Re: *Addendum No. 1*
Lyntz Road and Henn Parkway Resurfacing
Village of Lordstown

Proposal to Village of Lordstown
For Lyntz Road and Henn Parkway Pavement Resurfacing
Part A - Lyntz Road Resurfacing
Project No. 0000038219

SECTION 011100A - SUMMARY OF WORK

Add the Attached Drawing DD.5.

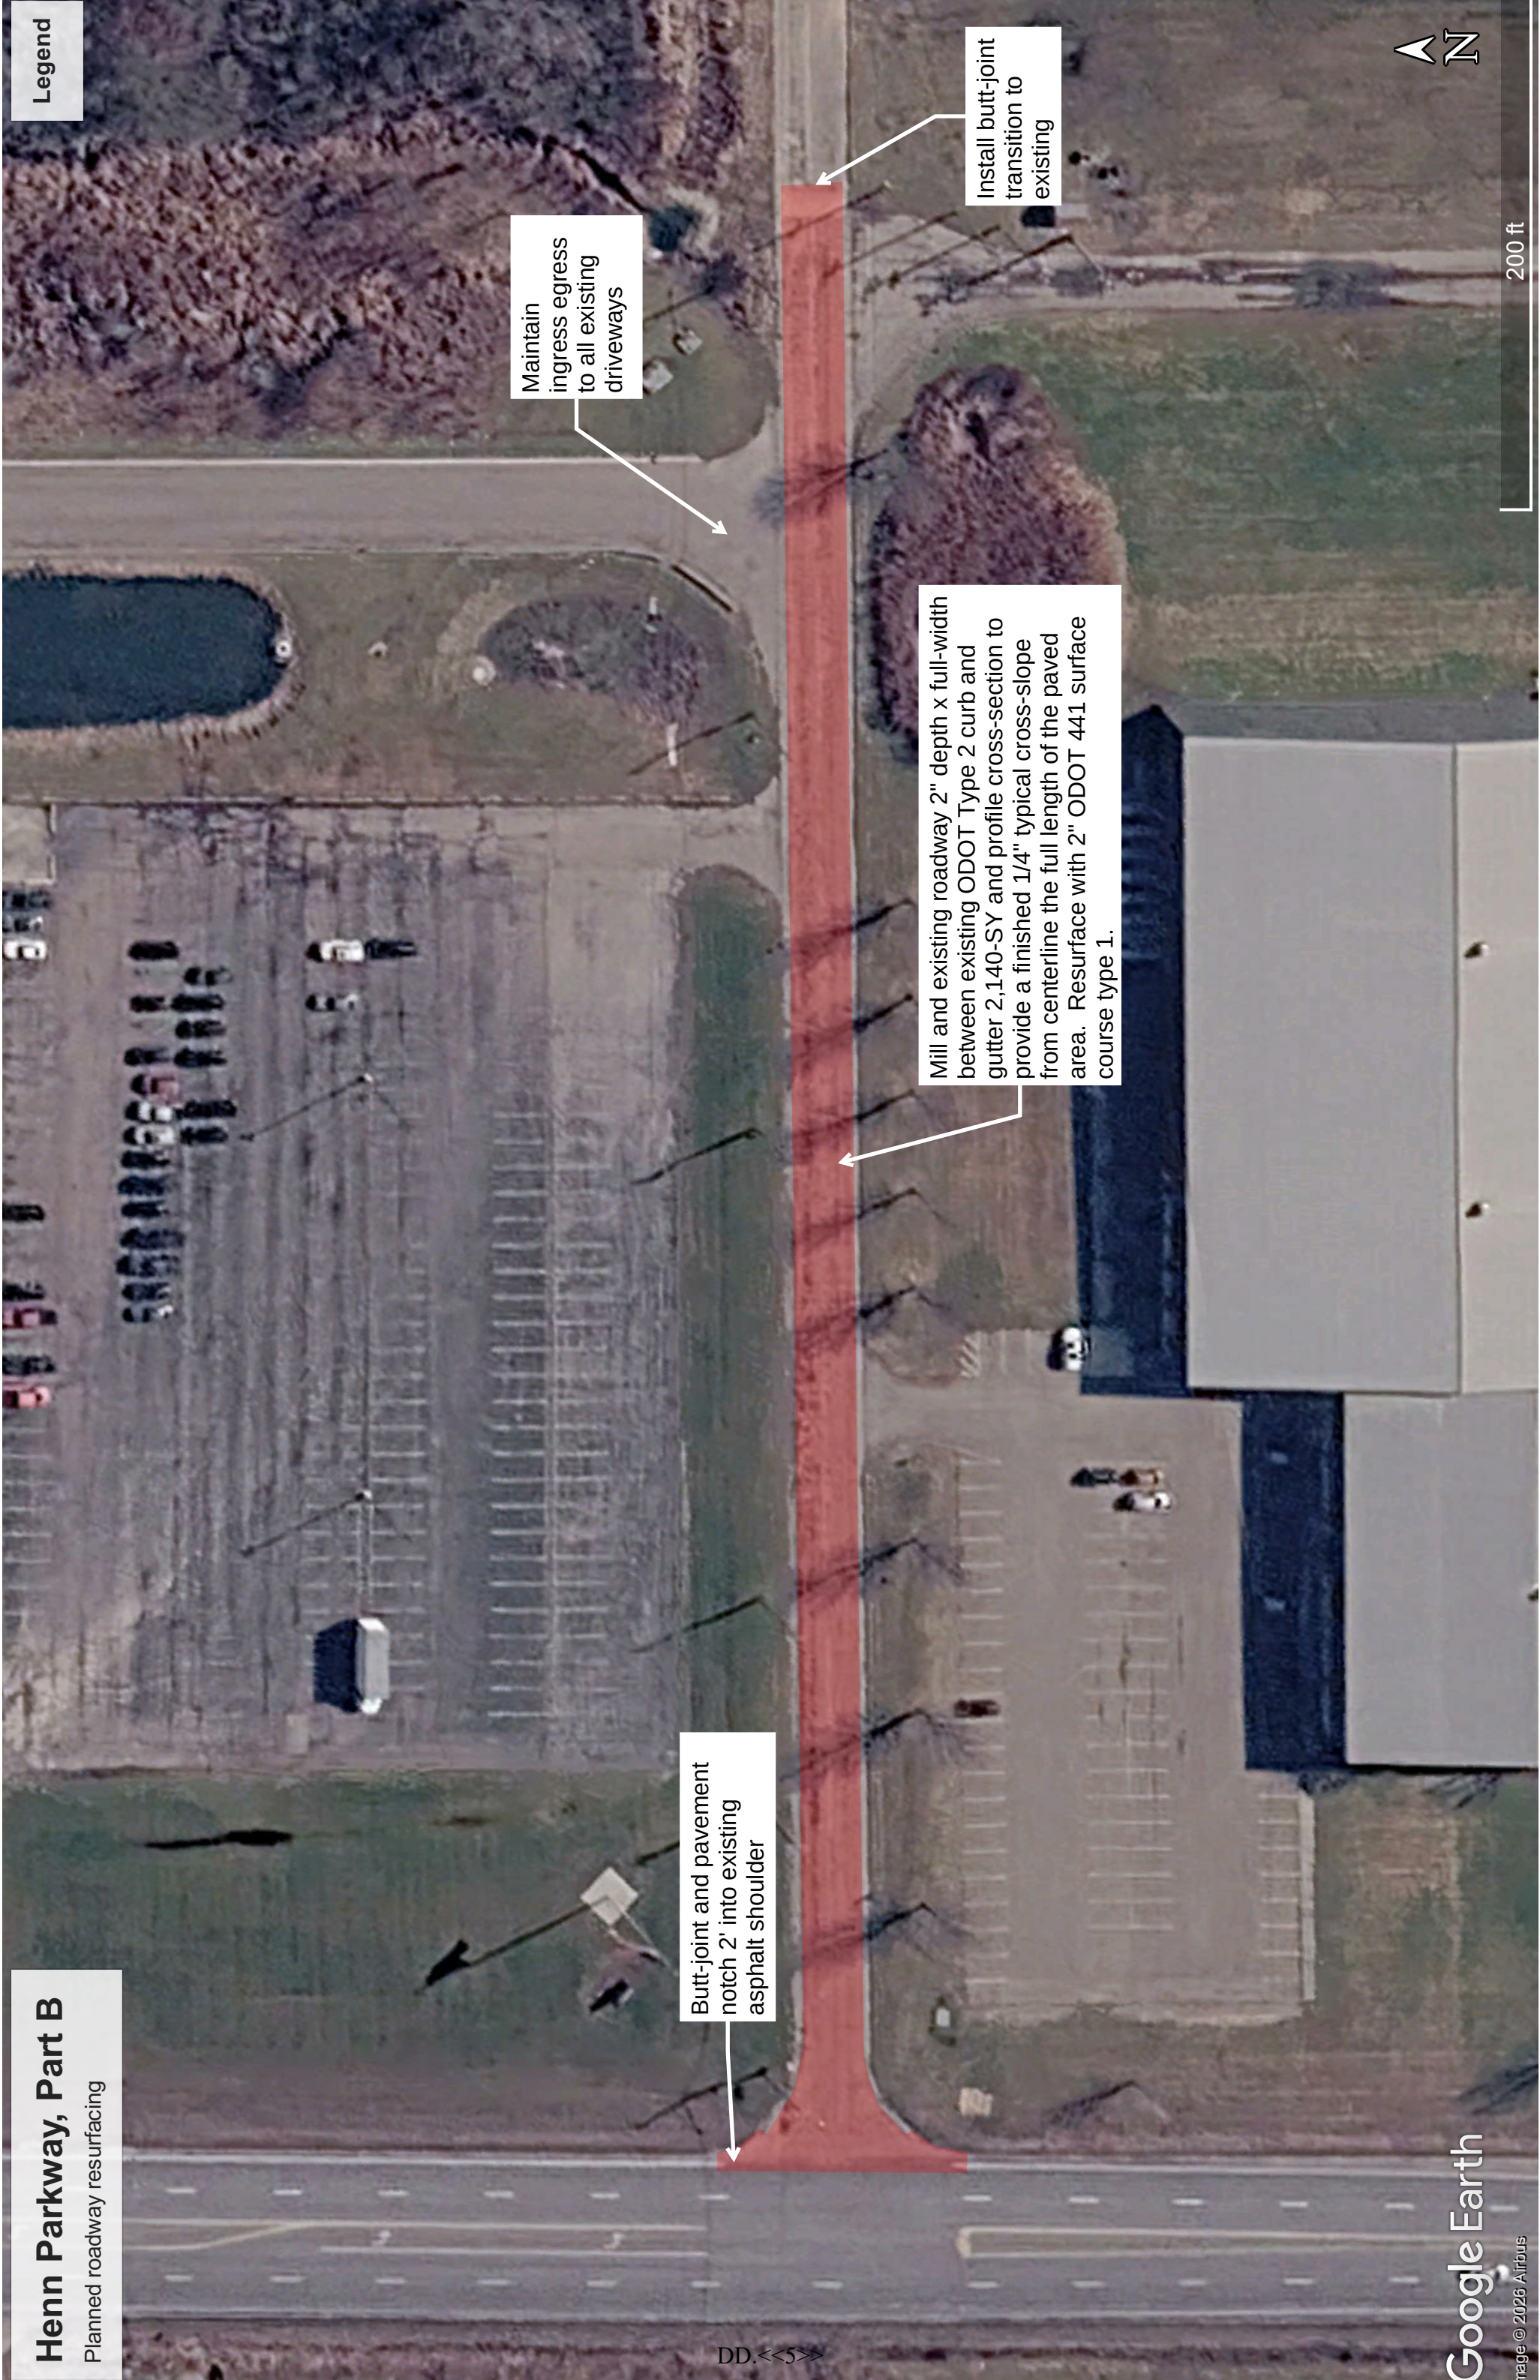
Maintain ingress egress to all existing driveways

Mill and existing roadway 2" depth x full-width between existing ODOT Type 2 curb and gutter 2,140-SY and profile cross-section to provide a finished 1/4" typical cross-slope from centerline the full length of the paved area. Resurface with 2" ODOT 441 surface course type 1.

Install butt-joint transition to existing

Butt-joint and pavement notch 2' into existing asphalt shoulder
